Stannah

TB 187

TECHNICAL BULLETIN

SUPPLIER ISSUE – LANDING ENTRANCE BOTTOM FIXINGS

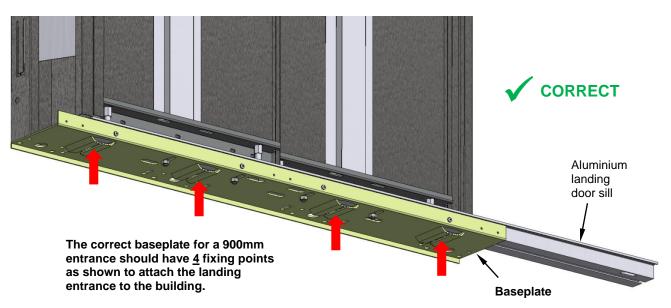
It has become apparent that some Piccolo Fermator landing door entrance sills have been supplied with an incorrect component.

The incorrect component is the <u>baseplate</u> which supports the aluminium landing door sill. This component should have 4 fixing points for attaching the bottom architrave brackets to the building (as shown below) but has been supplied incorrectly with only 3.

<u>Note:</u> This technical bulletin only relates to Piccolo models with a **900mm wide landing entrance** i.e. Piccolo models with cabin size 1100mm x 1400mm. Stannah part numbers for the landing entrances affected are 511150 and 511152.

Installations where Piccolo **900mm** wide landing entrances *have not* progressed beyond 1st fix (not built-in):

If inspection of the baseplate confirms that it only has 3 fixing points for the architrave brackets then it must be replaced with the correct baseplate with 4 fixing points.

Unscrew the fixings securing the incorrect baseplate and replace with the correct version in the same location.

Installations where Piccolo **900mm** wide landing entrances *have* progressed beyond 1st fix (are built-in):

The baseplate does not have to be replaced.

The customer will be asked to check the different load condition now imposed on the building, to that shown on the corresponding Builders Work Drawing.
